PROJECT: DISCOVERY HILLS UNIT 1 - UPDATE

SUBMITTAL: 4TH

CITY OF LAS VEGAS		DATE:
INTER-OFFICE MEMORANDUM		February 2, 2001
TO: Land Development Services Department of Public Works		FROM: Randy Fultz, P.E. <i>RF</i> Flood Control Project Manager Department of Public Works
SUBJECT:	Drainage Study for:	
	Discovery Hills Unit-1 (Update)	
Cross Streets:	Falls Church & Snow Mountain	
FILE NO.:	F:\Depot\DSMEMOS\DS1519D.doc	
Parcel Number:	13725517007	
Zoning Action:		
FEMA Flood Zone	YES	No X
Proposed Storm Drain	YES X	No
COPIES TO:		Southwest Engineering Cheri Edelman, P.E., DEVCO

Submerged Weir Calculation

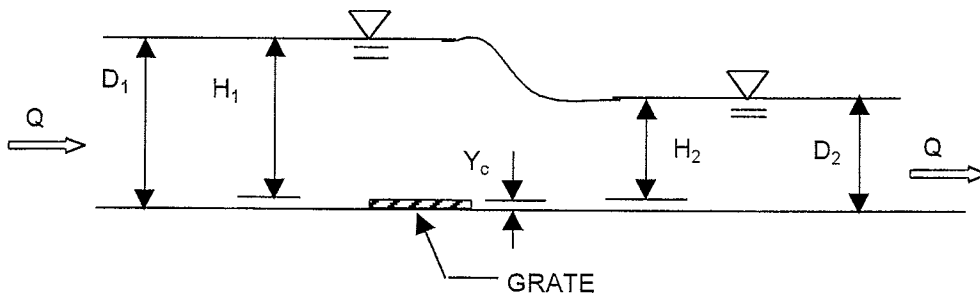
- The revised plans do not meet current design criteria standards. Provide a discussion comparing the weir flow depth in the street to the garage and Lot 1 finish floor. The calculations provided show the weir flow depth at 1 foot above the top of grate, which is at elevation 10.62. This gives a water surface elevation of 11.62, which is 0.26 feet above the garage finish floor and only 0.15 feet below the finish floor of the home. Provide a statement regarding the adequacy of the proposed changes to protect the existing structure.

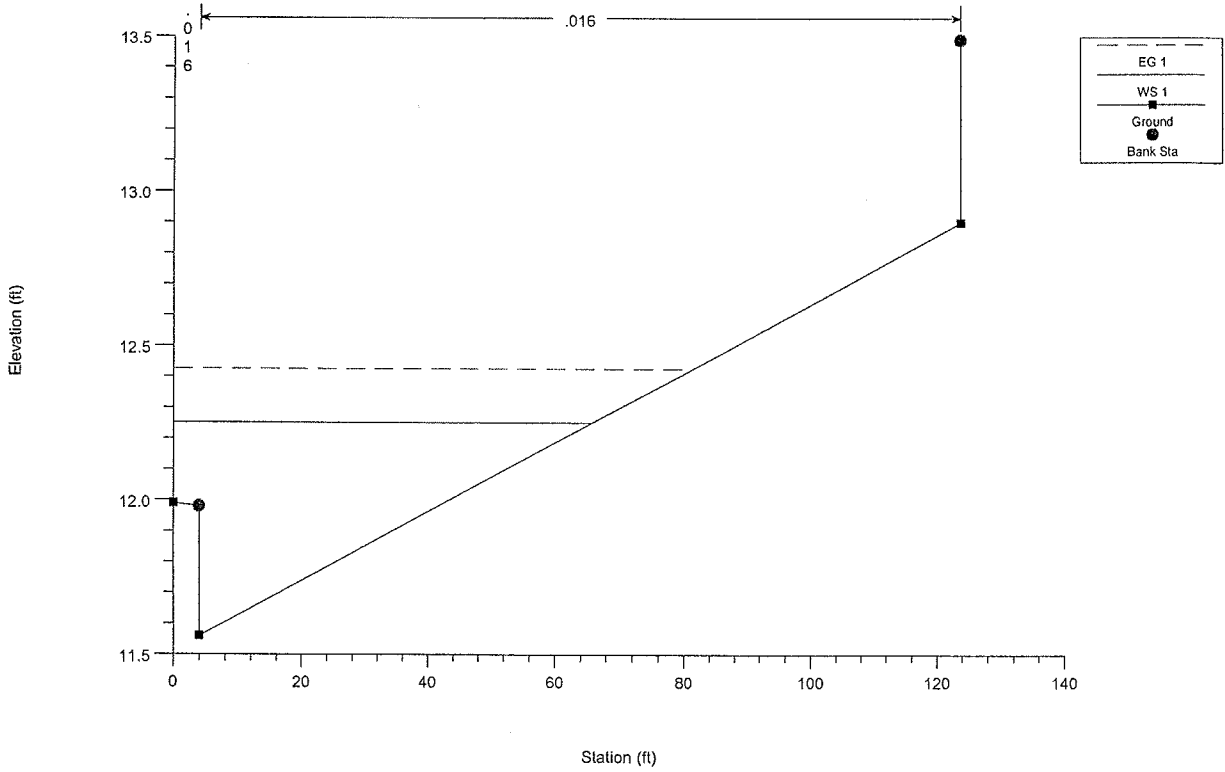
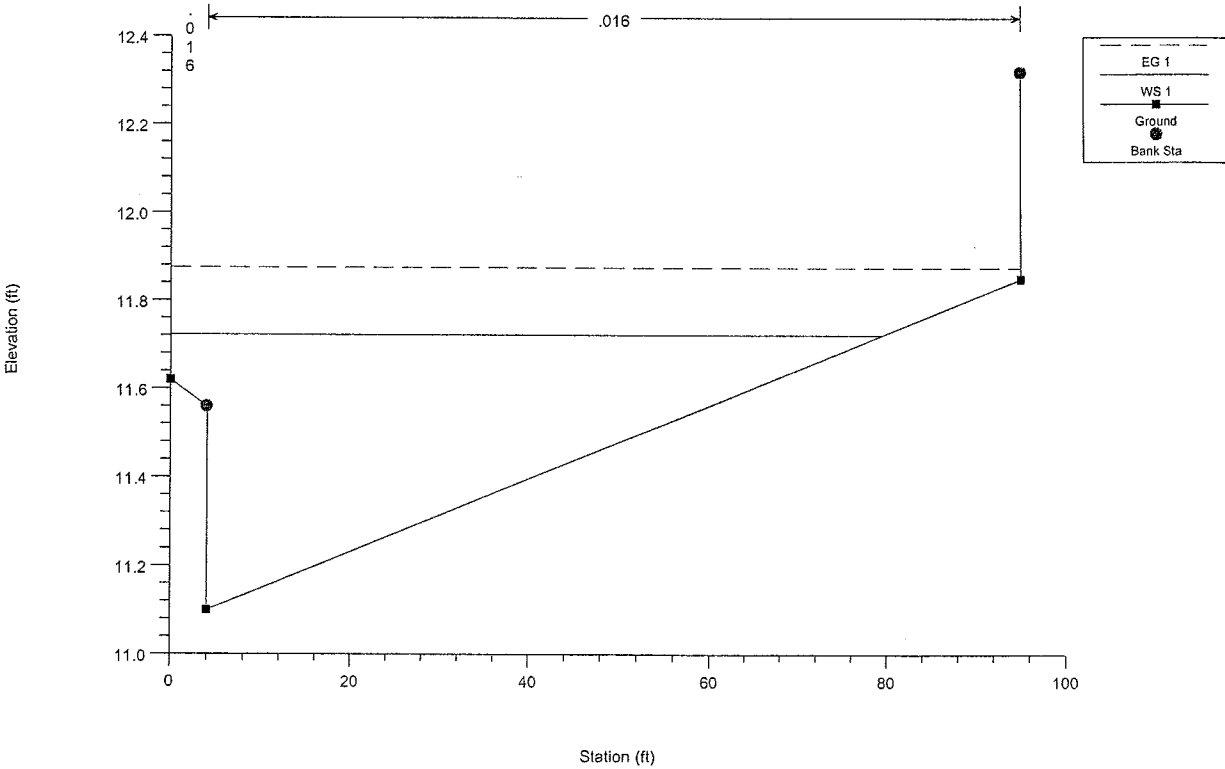
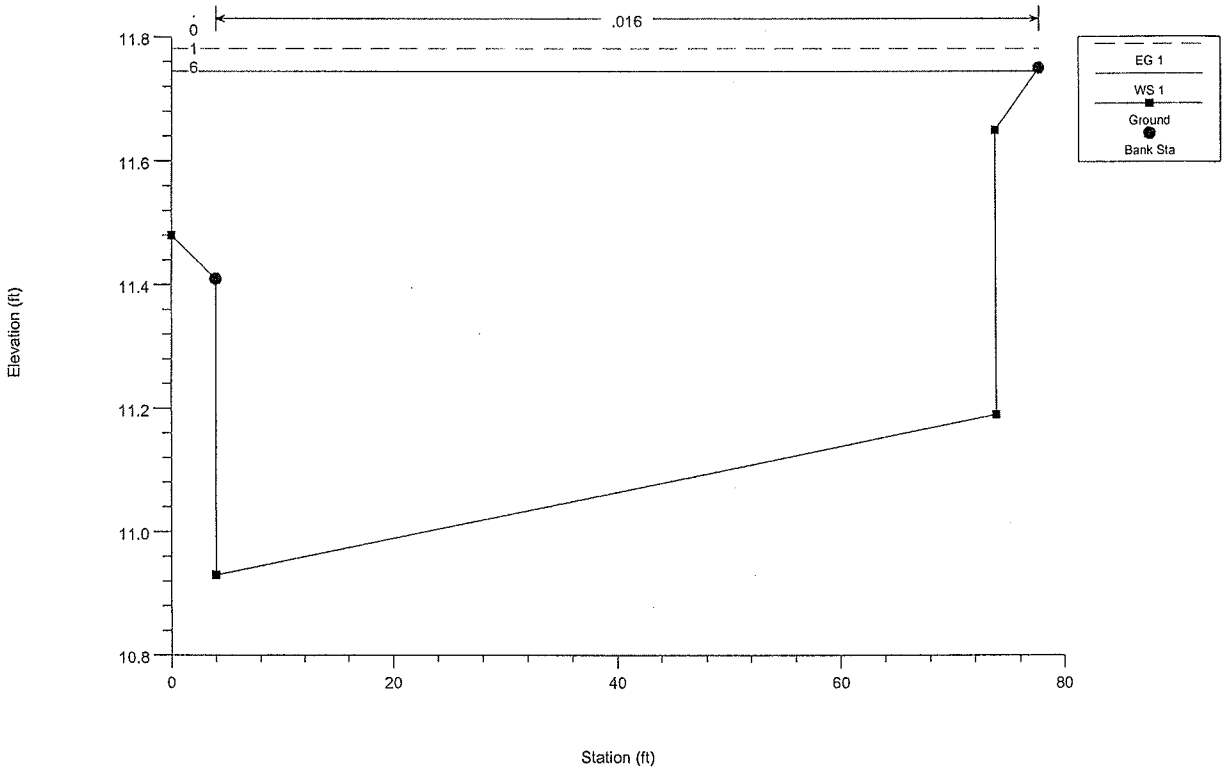
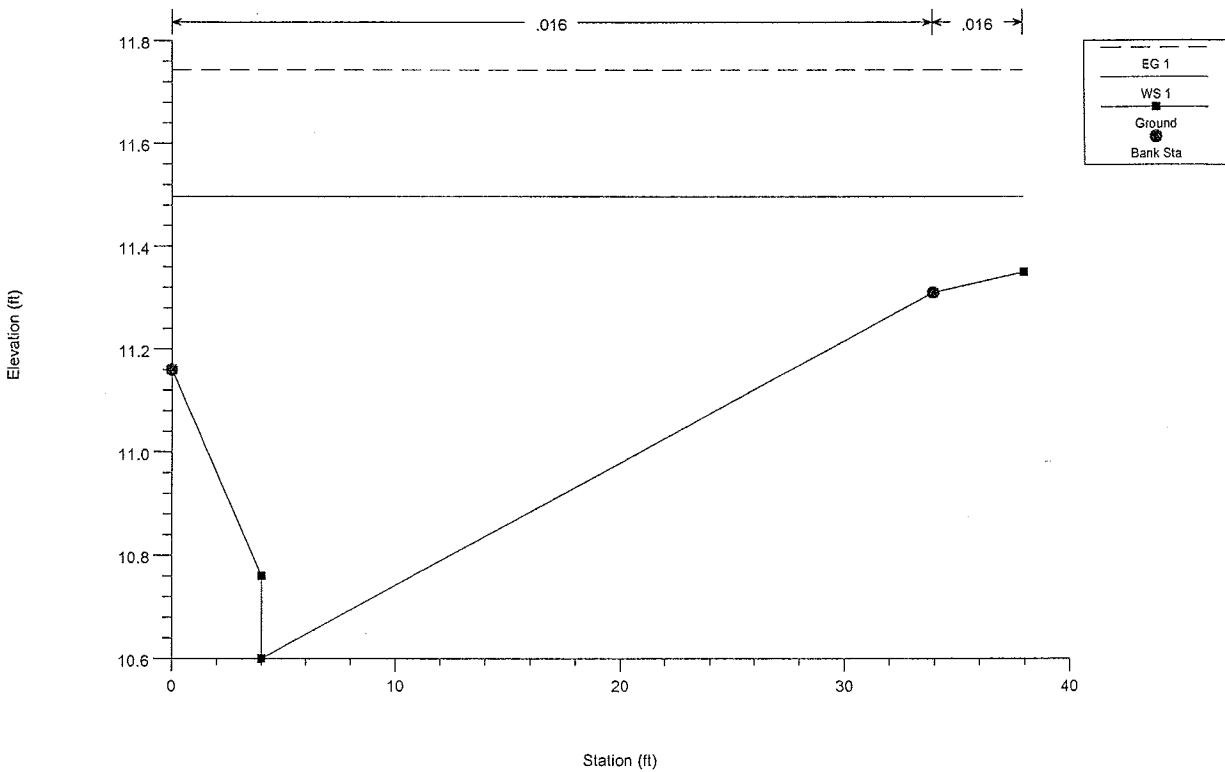
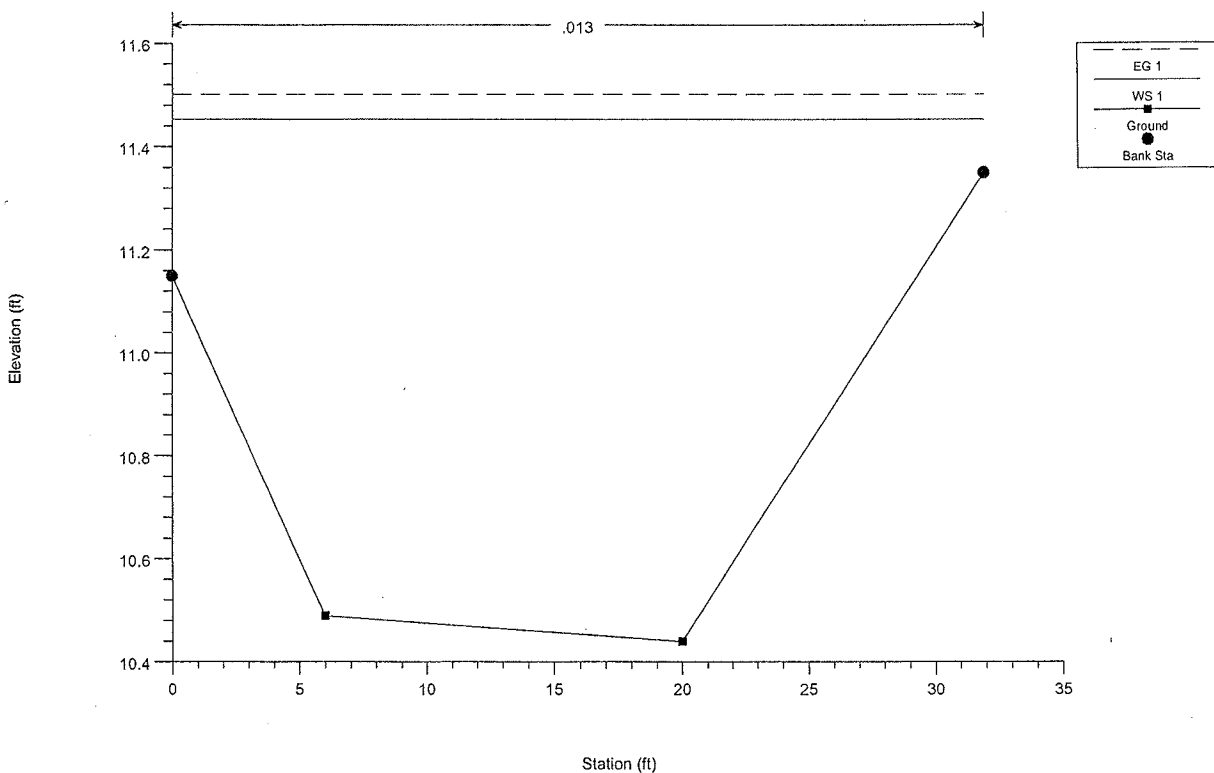
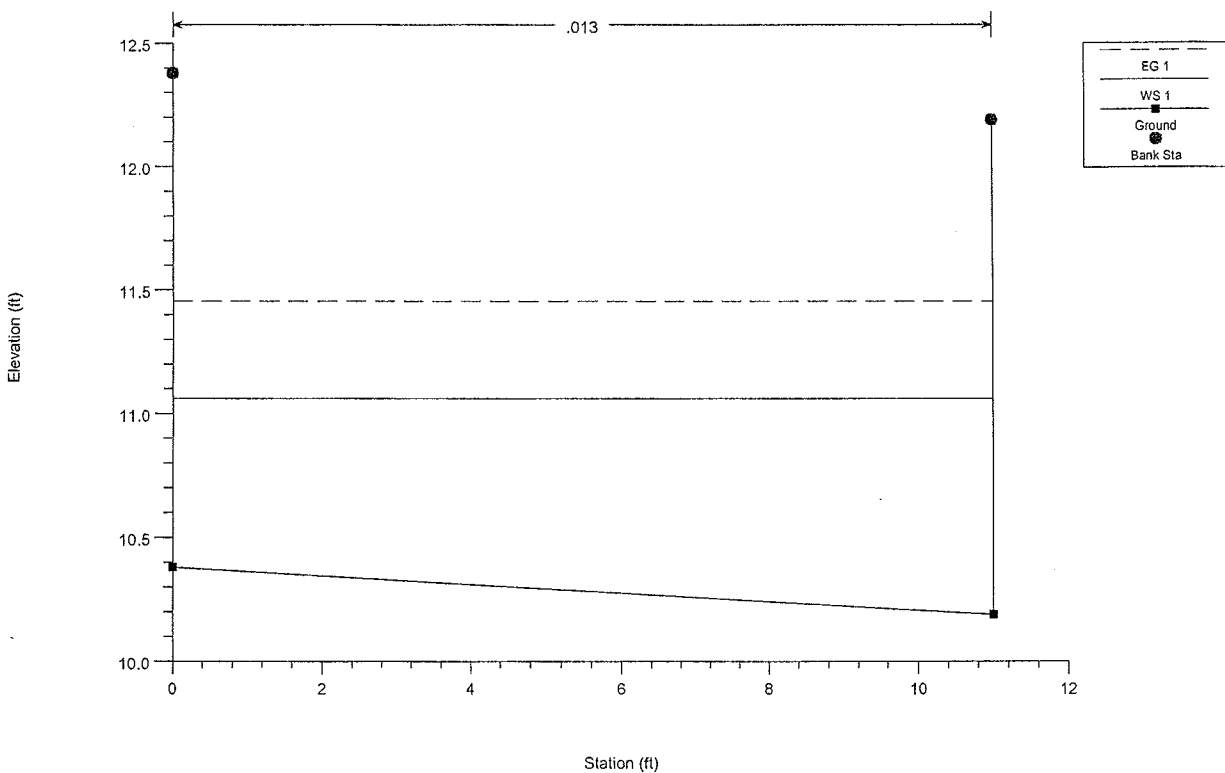
5. Label the HEC-RAS sections on sheet 4A or provide a separate exhibit showing the sections and add more sections upstream and downstream.
6. Provide cross section details for the modified area showing existing and proposed features. Provide sufficient elevations on plan to clarify the proposed modifications.
7. Revise sheet 4A to show existing bollards. Show proposed bollards, if necessary, to block access to the revised easement.
8. The following comments apply to the grading sheet 4A:
 - A. Show and label the existing storm drain pipe and inlets on sheet 4A.
 - B. Provide top of grate elevations for the revised inlet on the plan.
 - C. Label the "W" dimension on Section B. 5 feet as scaled from the plan view.
 - D. Label the existing storm drain size and slope on Section B.
